SCH: 650-02254-02-SCH
ASSY: 650-02254-02
PCB: 651-02254-02

BITLAND		Bitland Information Technology Co.,Ltd.	
Page Name		SUB BOARD SCH: TYPE-C	
Size C	Project Name Phaser	Rev 1.3	
Date:	Tuesday, November 27, 2018	Sheet	5 of 5
PROPERTY NOTE: this document contains information confidential and property to Bitland Technology Co.,Ltd. and shall not be reproduced or transferred to other documents or disclosed to others or used for any purpose other than that for which it was obtained with the expressed written consent of Bitland

BITLAND			
Bitland Information Technology Co.,Ltd.			
Page Name	SUB BOARD SCH: TYPE-A		
Size	Project Name	Phaser	Rev 1.3
C	Thursday, November 22, 2018		
Date	Sheet	8	of 8
PROPERTY NOTE: this document contains information confidential and property to Bitland Technology Co.,Ltd. and shall not be reproduced or transferred to other documents or disclosed to others or used for any purpose other than that for which it was obtained with the expressed written consent of Bitland

DAUGHTER BOARD

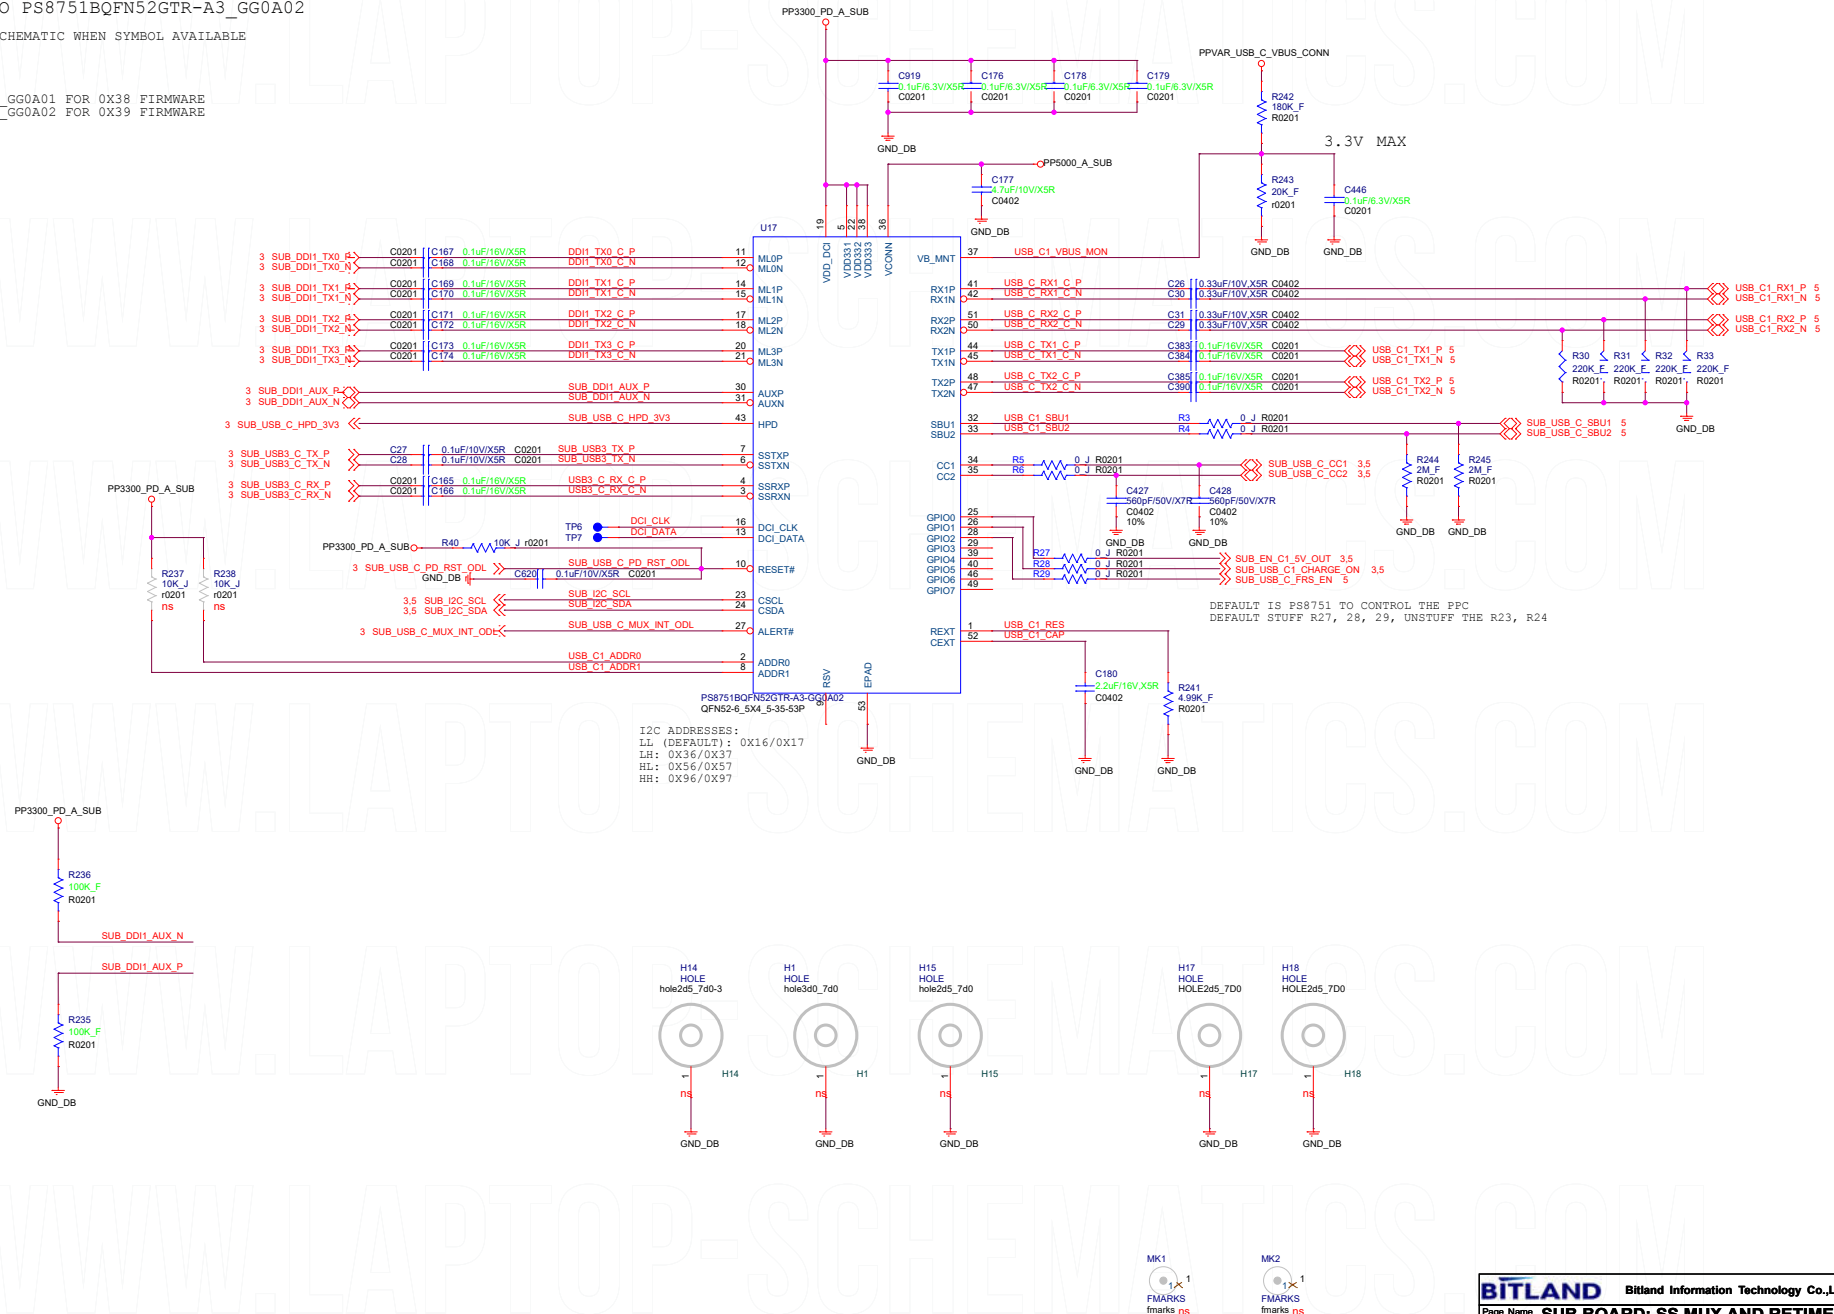
UPDATE PART TO PS8751BQFN52GTR-A3_GG0A02

WILL UPDATE THIS SCHEMATIC WHEN SYMBOL AVAILABLE

```
PS8751BQFN52GTR-A3_GG0A01  FOR 0X38 FIRMWARE
PS8751BQFN52GTR-A3_GG0A02  FOR 0X39 FIRMWARE
```

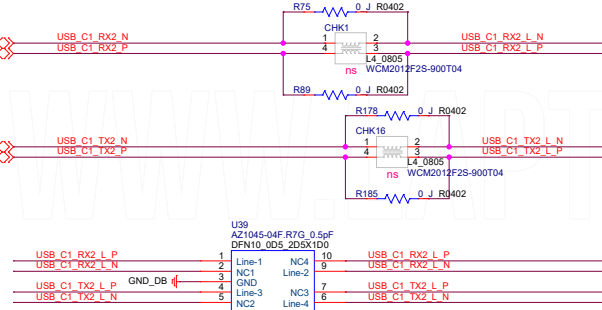
Deviation:
Change PCMF2USB3S to discrete EMI filter and ESD---0315

PORT 1

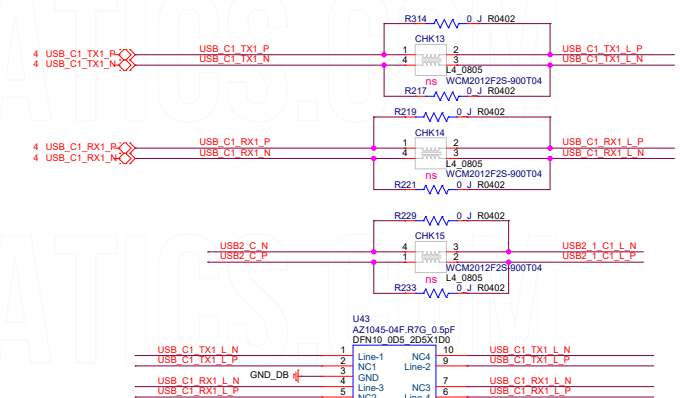
Deviation:
Change PCMF3USB3S to discrete EMI filter and ESD---0315

DAUGHTER BOARD

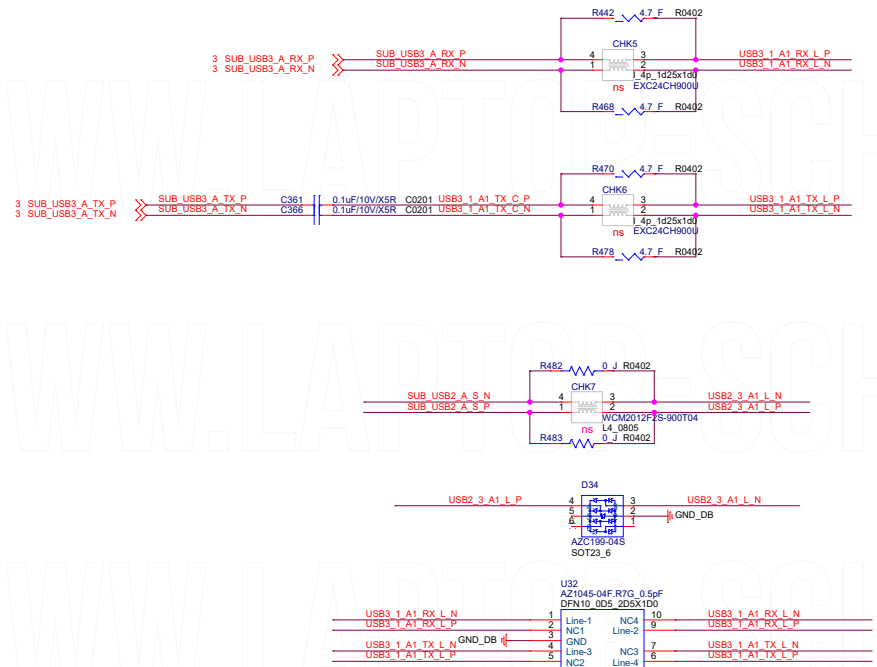
Deviation:
Change L18 (PCMF3USB3S) to discrete EMI filter and ESD---0315
